ARCHITECTURAL SUPPLEMENTAL INSTRUCTION:
ALL TERAZZO INSERT DIMENSIONS (TOTAL WD & HGT) ARE 1/4" MODULAR TO FIT WITHOUT
IRREGULAR OR ADDITIONAL TILE CUT INTO 1/4"X28" FLOOR TILE PATTERN.
TERAZZO AND TILE CONTRACTOR ARE REQUIRED TO COORDINATE AND
CONFIRM FINAL SIZE AND PLACEMENT OF TERAZZO ART INSERTS.

**ST PETE CLEARWATER AIRPORT
INTERIOR TILE PROJECT**
(IN ADDITION TO CORRIDOR TILE PROJECT)

Drawing Name:
**FLOOR PLAN
TERAZZO DETAIL**

Drawing Number:
I.1.10

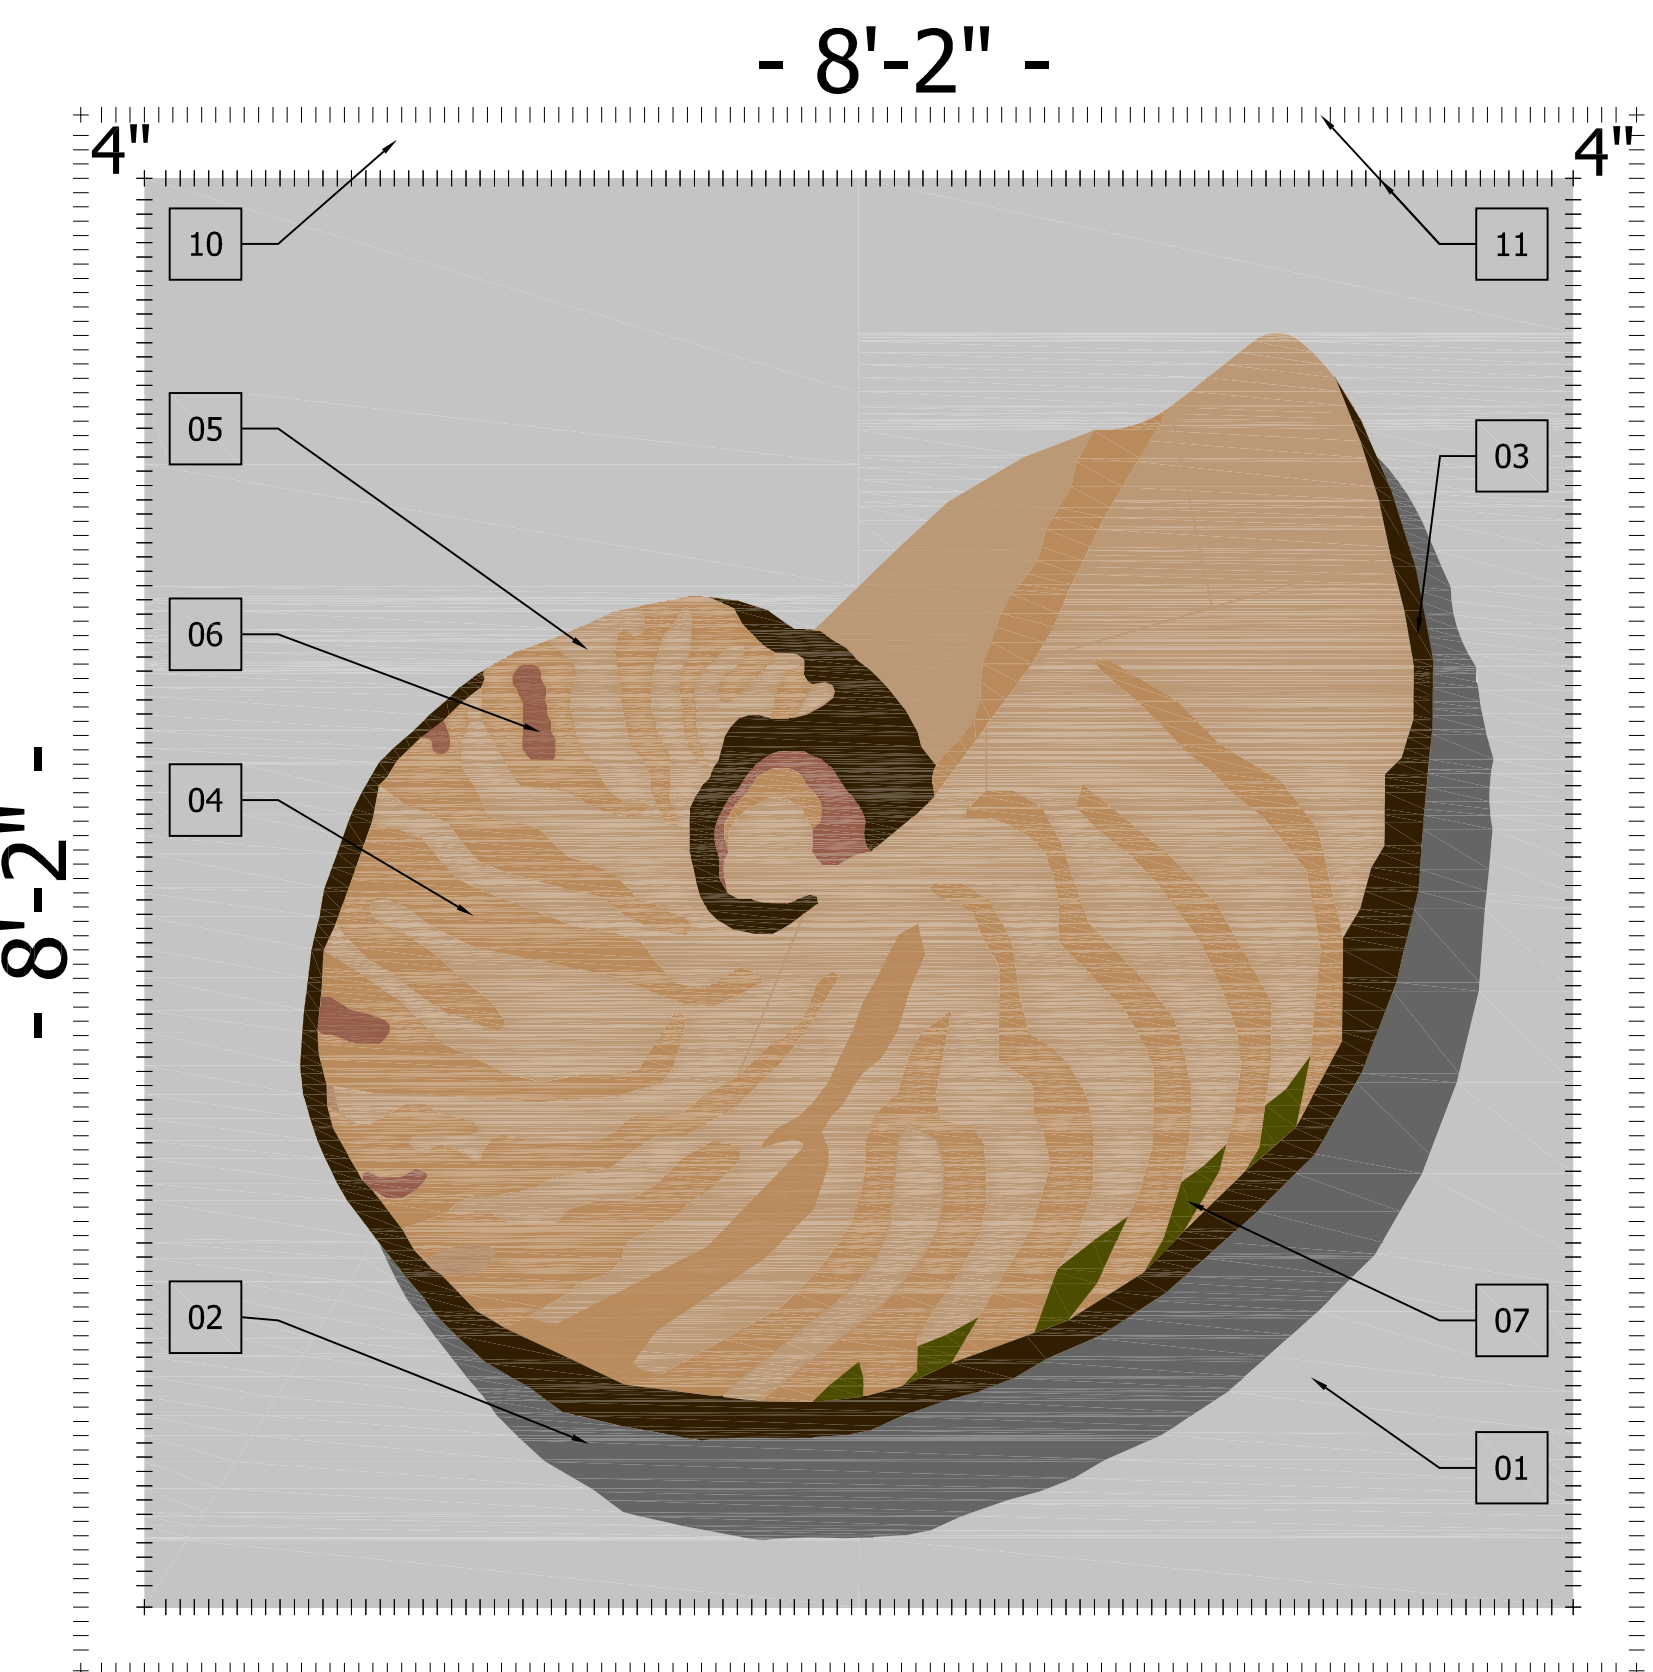
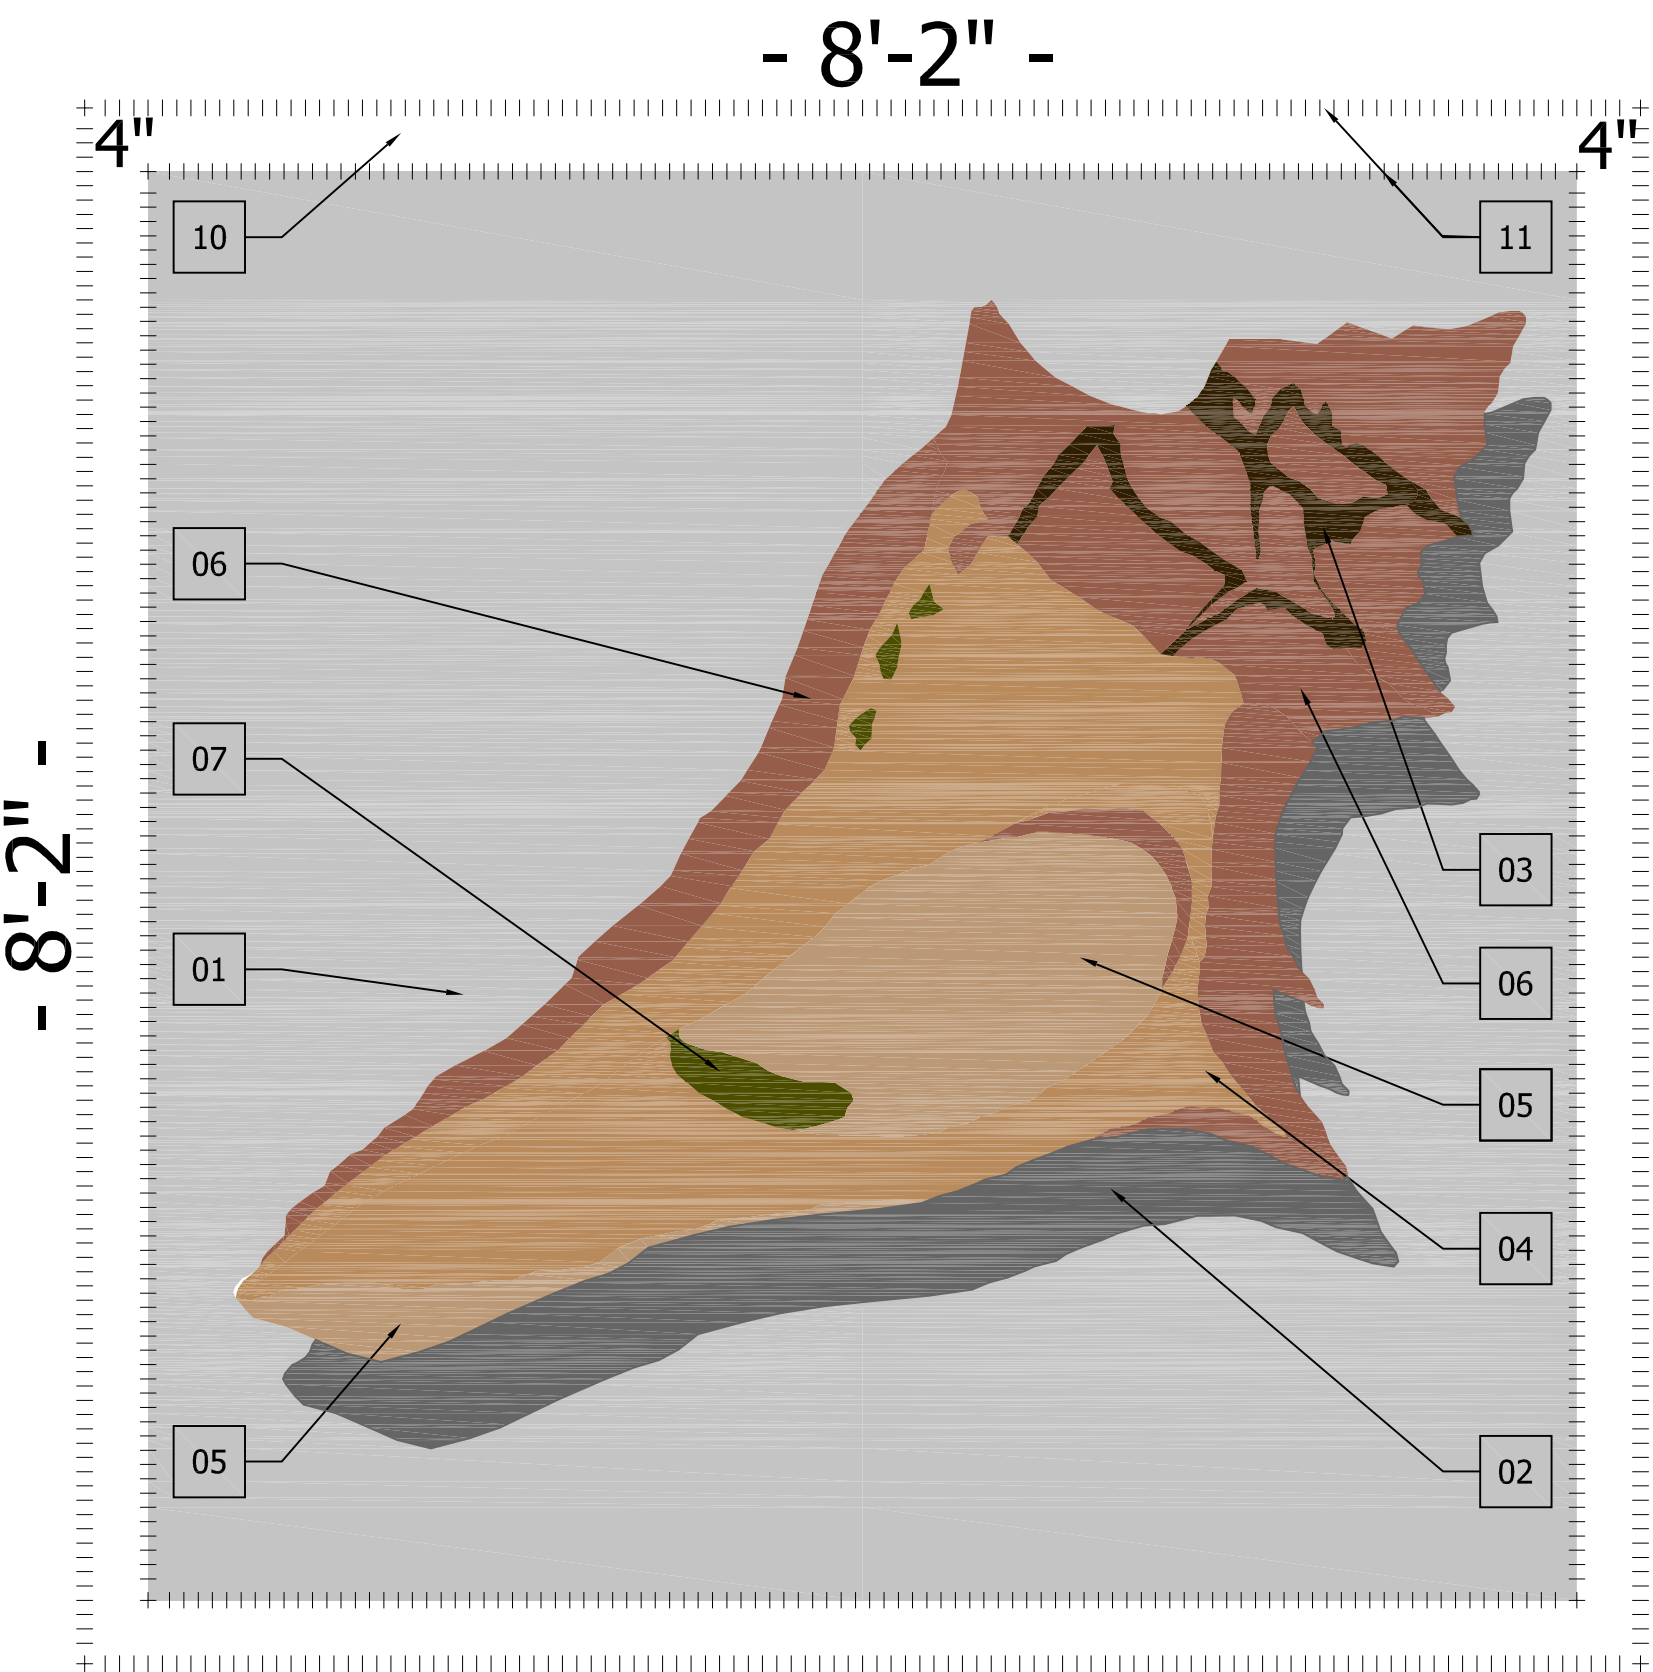
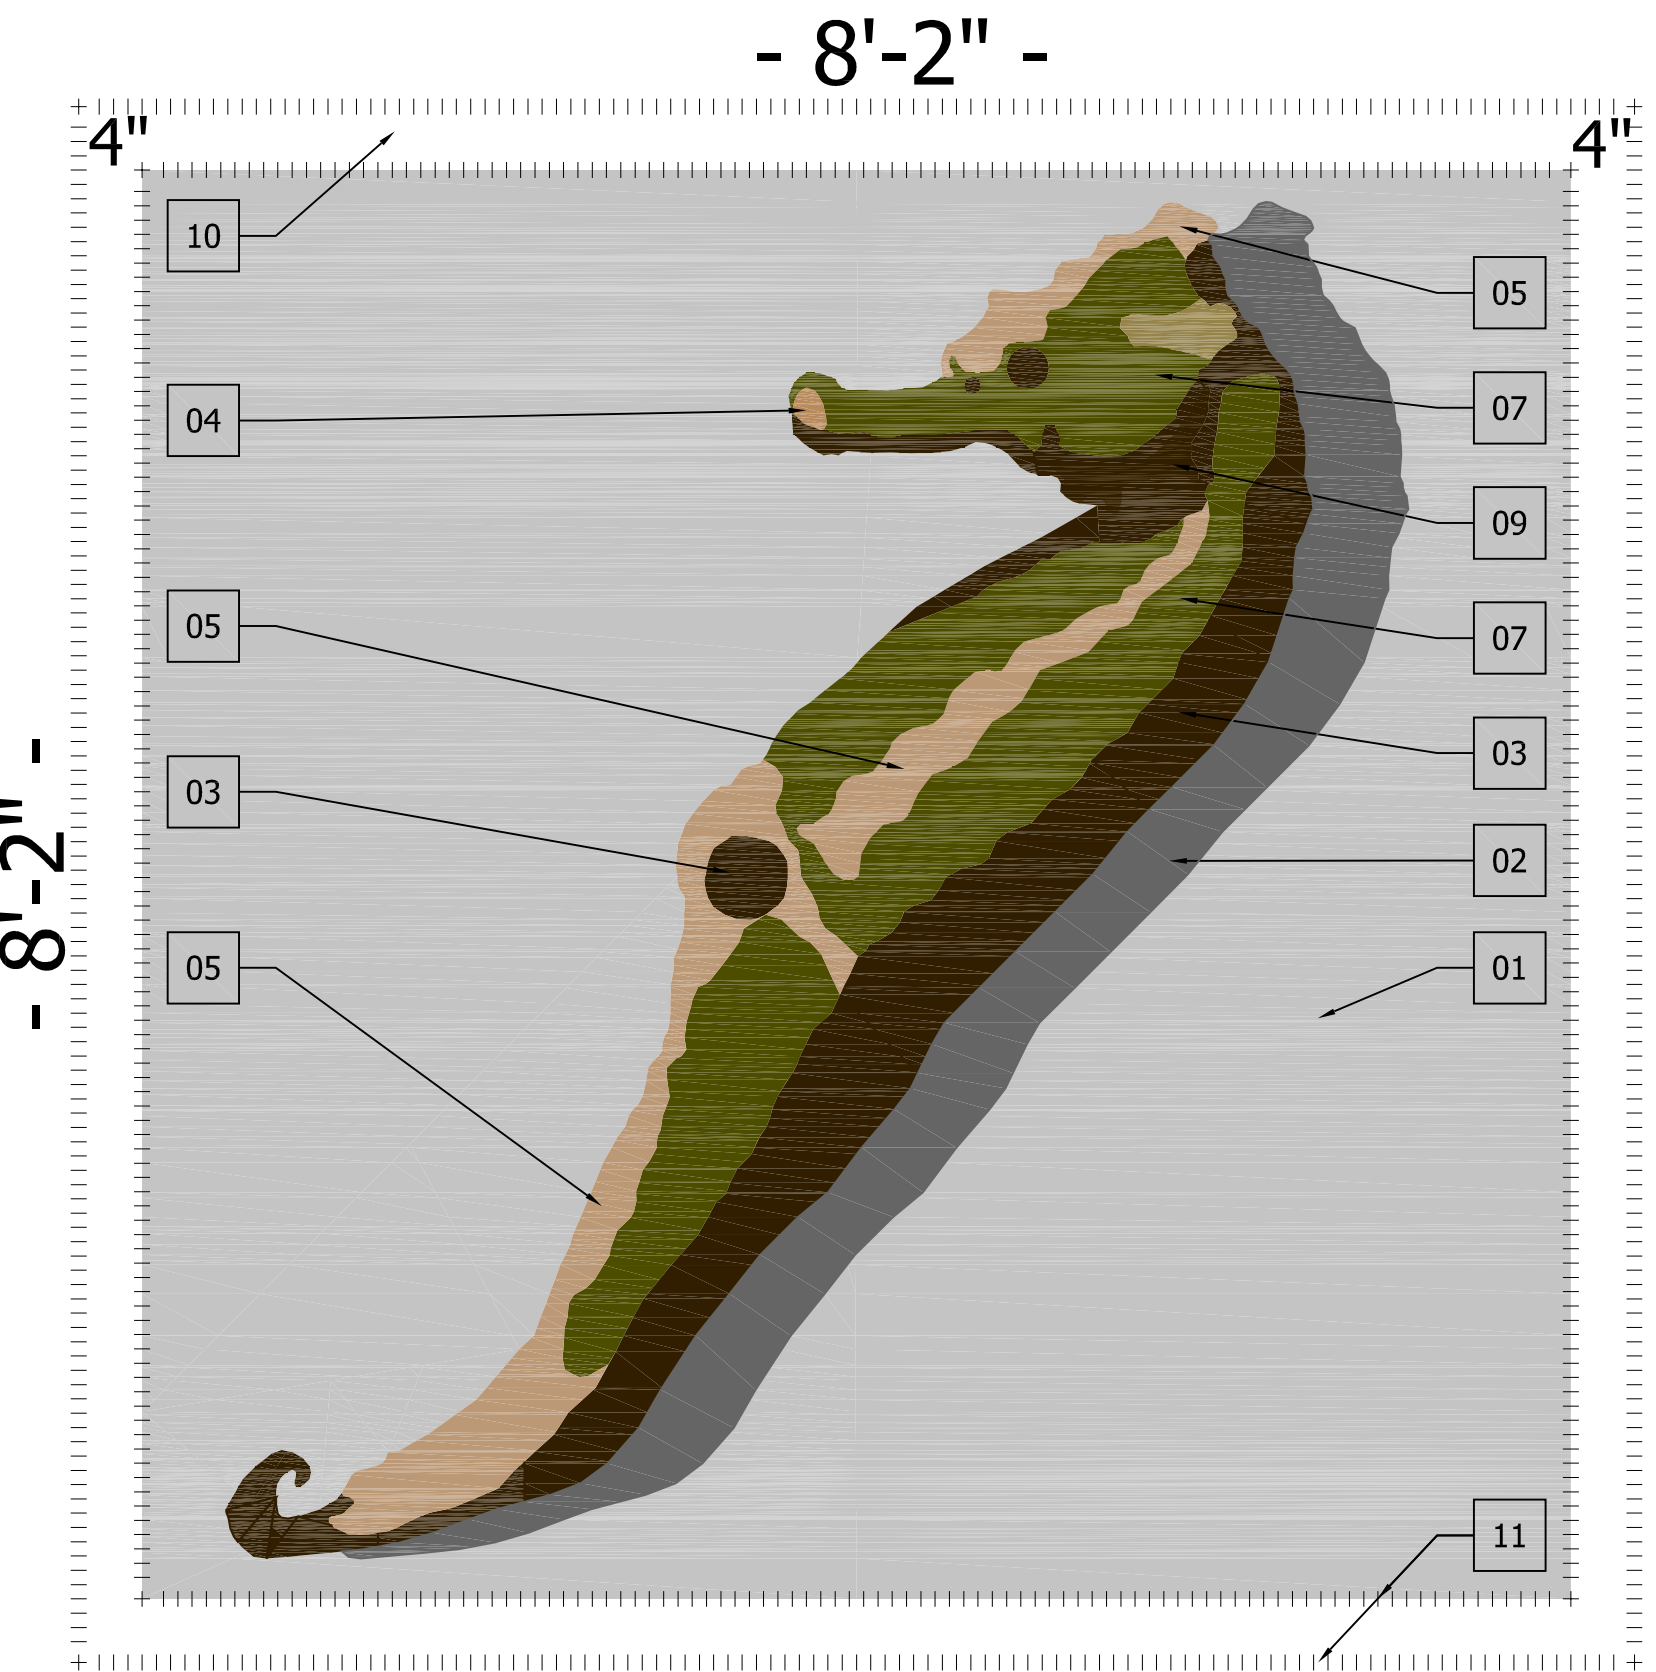
| No. | Description | Date | By |
|-----|------------------------------|----------|----|
| 1 | ASH: CORRECTION OF TOTAL HGT | 07.06.09 | SB |
